RAI: Volume 3, Chapter 2.2.1.1, First Set, Number 1:

1 RESPONSE

Figure 1-1. Seepage Rate as a Function of Percolation Flux

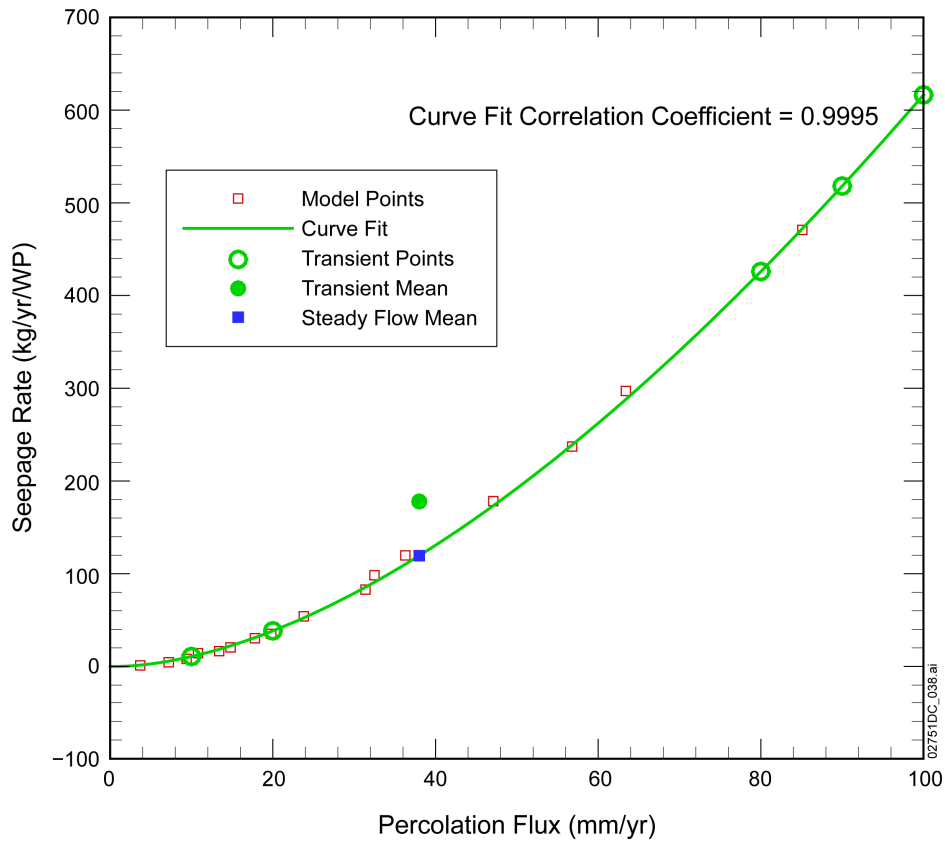
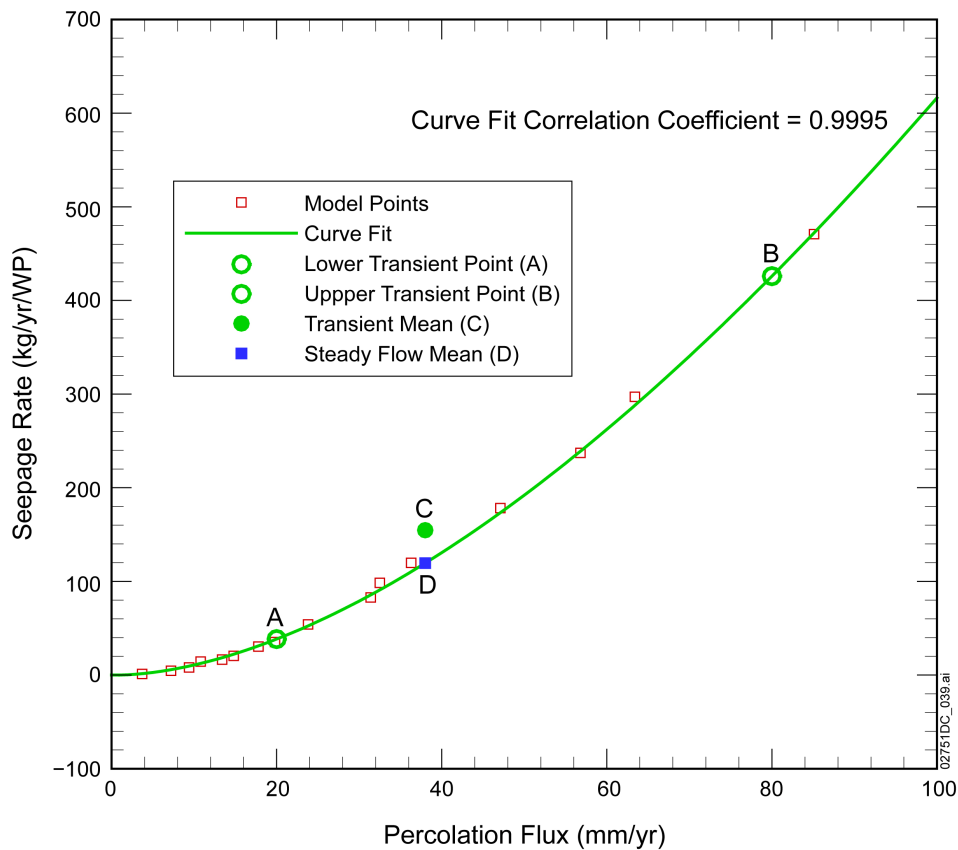
Figure 1-1. The asymptotic linear behavior of the seepage rate curve occurs at percolation rates in excess of 100 mm/yr.

Consider a transient percolation process defined by a series of steady percolation flux conditions over time. The seepage rate for each steady percolation flux condition is plotted on the seepage rate curve, shown as open circles in Figure 1-1. The seepage rate for the equivalent steady percolation flux is shown as the filled square in Figure 1-1.

Because the seepage rate curve is convex, the seepage rate for the equivalent steady percolation flux is always less than the time-weighted average of the transient seepage rates (filled circle in Figure 1-1). This leads to the conclusion that the damping of transient flow by the PTn will always lead to a reduction of water flowing into the drifts.

Figure 1. Fraction of Seepage that Can Enter a CSNF Waste Package with General Corrosion Breaches at Various Percentiles of the Uniform Distribution of f'_{WP}

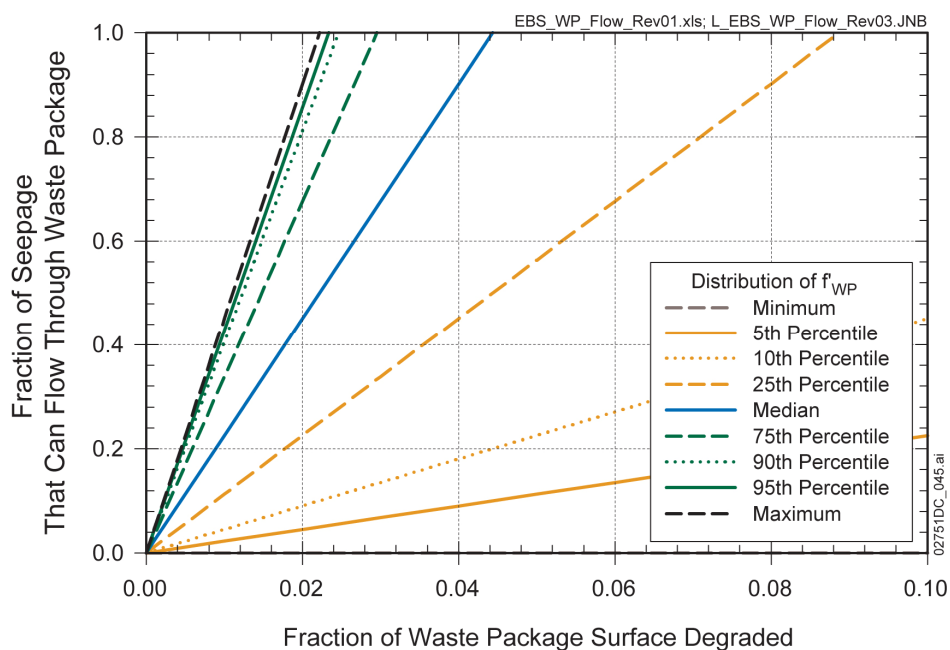
Figure 1 shows the fraction of seepage that would flow through a CSNF waste package as a function of the fractional area of the waste package surface degraded (i.e., damaged by general corrosion) for various percentiles of the uniform distribution of the uncertainty factor for rivulet flow, f'_{WP} . It can be seen that a relatively small fraction of the waste package surface needs to be breached by general corrosion to allow all of the drift seepage to enter the waste package; for example, when 4% of the surface is penetrated by general corrosion, the fraction of seepage that flows through a CSNF waste package ranges from 0 to 1.0, with a median fraction of seepage of 0.92 flowing through a waste package. As shown later in this response, the average fractional

area of the waste package surface degraded in 1,000,000 years is smaller than this example, with the result that on average a breached waste package diverts a large fraction of drift seepage.

SAR Figure 2.1-16. Summary Statistics for Fraction of CSNF Waste Package Surface Breached by Patches per Breached Waste Package for (a) the Seismic Ground Motion Modeling Case and (b) the Nominal Modeling Case, as a Function of Time

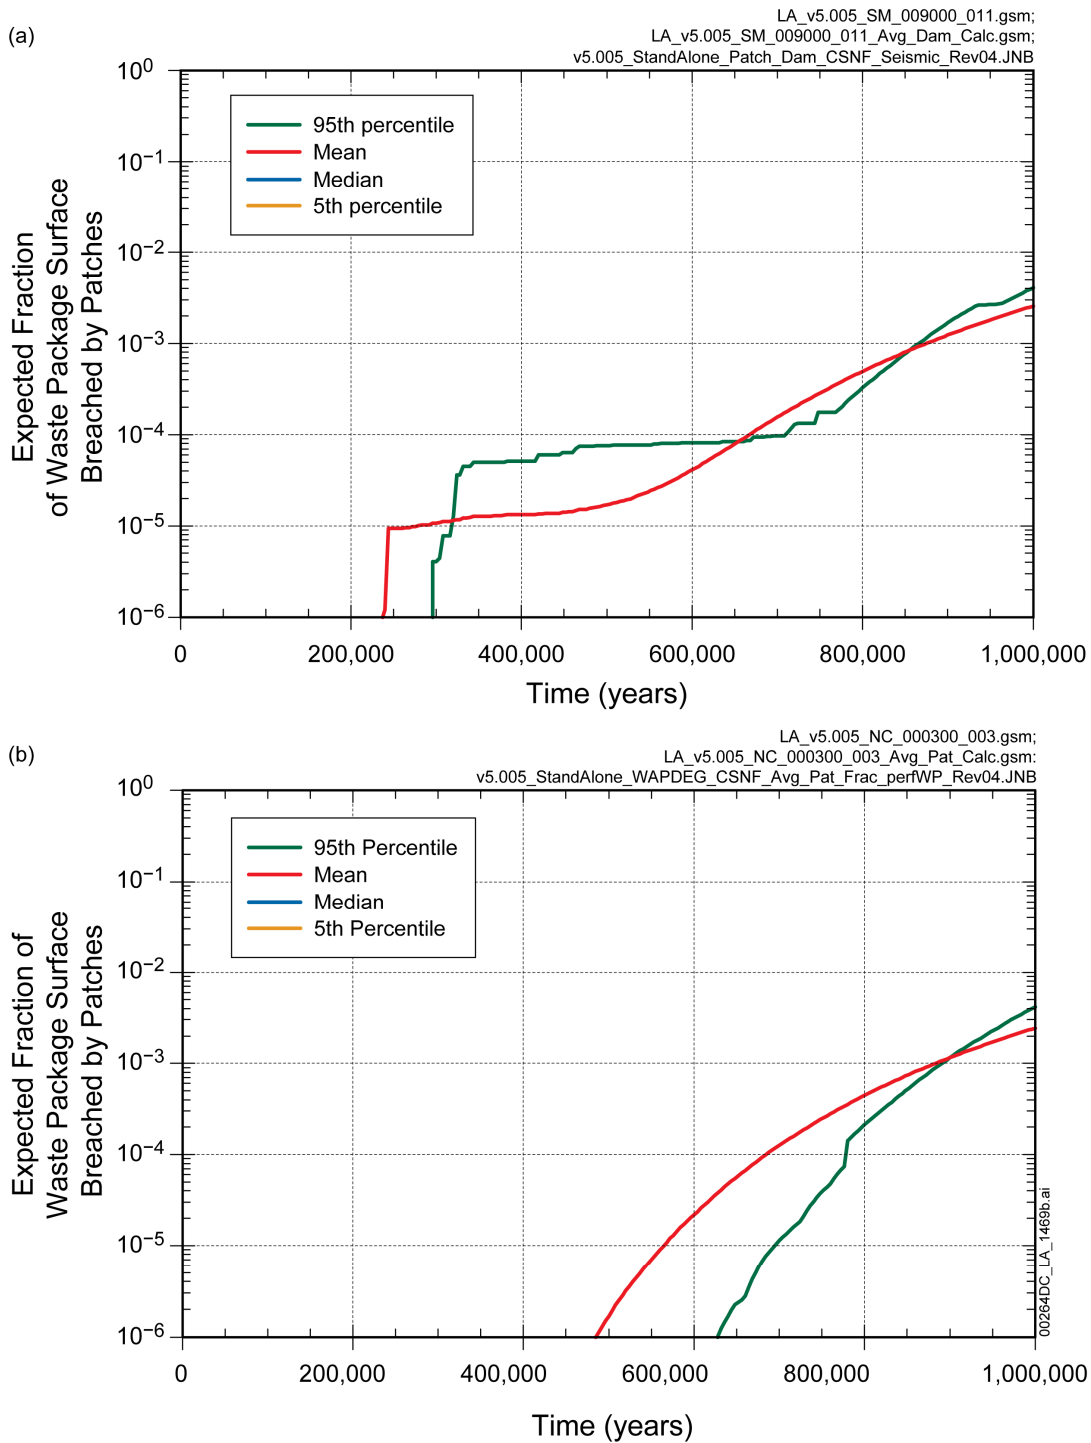
As indicated in SAR Figure 2.1-16(a) (reproduced below), the mean curve for the outer barrier average patch-breach area fraction begins abruptly at approximately 240,000 years. The 5th percentile and median are absent from the plots because of the large number of realizations in which no patch breaches occur within 1,000,000 years (SAR Section 2.1.2.2.6). This abrupt increase results from the first occurrence of rupture or puncture in the waste package outer barrier. Once they occur, ruptures and punctures are modeled in the same way as general corrosion patches. Ruptures and punctures can only occur to waste packages that have been weakened by internal corrosion resulting from moisture entering the waste package through previously formed cracks. Therefore, two separate seismic events of sufficient magnitude are required, the first to cause the crack damage and the second to cause the rupture or puncture. Due to the low probability of seismic events that cause crack damage to CSNF waste packages, as well as the low probability of seismic events that subsequently induce ruptures or punctures in the waste package outer barrier, ruptures and punctures occur in only a few realizations (see SAR Section 2.3.4.5 for details regarding the response of the waste package to seismic events).

Accordingly, until about 480,000 years, the mean curve remains relatively flat, because it is determined by the few realizations in which ruptures or punctures occur. After 480,000 years, the mean curve ascends gradually, corresponding to an increasing likelihood that general corrosion penetrations have occurred. The timing of the initiation of the general corrosion patch penetrations is consistent with the mean curve for the nominal conditions shown on SAR Figure 2.1-16(a). At the end of 1,000,000 years, the mean patch-breach area fraction attributed to seismic conditions, shown in SAR Figure 2.1-16(a), is about 0.26%, whereas for nominal conditions, shown in SAR Figure 2.1-16(b), it is about 0.24%. This small difference between seismic and nominal patch-breach area fractions means that the fraction of surface area breached by patch penetrations on the CSNF waste package outer barrier is dominated by the general corrosion degradation.

Note that the expected fraction of waste package surface breached by patches shown in SAR Figure 2.1-16 is averaged over the entire repository. Not only is the number of realizations with no patch breaches large, as noted above, but also in any given realization the number of waste packages in the repository having no patch breaches is large. By 1,000,000 years, the mean fraction of the CSNF waste packages with at least one patch breach is approximately 9% (SNL 2008, Section 8.3.3.2.1[a]). This indicates that about 90 percent of the CSNF waste packages in the repository would not exhibit general corrosion patch penetrations before 1,000,000 years and would divert all seepage water over that time period.

The 95th percentile curve in SAR Figure 2.1-16(b) demonstrates the effect of uncertainties in the TSPA model on the fraction of waste package surface that is breached by general corrosion and hence on the capability of a breached waste package to divert seepage water. In the 95th percentile curve, patches begin to appear at about 640,000 years, and the expected fraction of waste package surface breached by patches reaches about 0.41% at 1,000,000 years. At that time, the average fraction of seepage that can enter a waste package breached by general corrosion will range uniformly from zero to a maximum of 0.19, with a median fraction of seepage that can enter a waste package of 0.095, accounting for the range in the uncertainty factor for the fraction of flow that enters a breach, f'_{WP} .
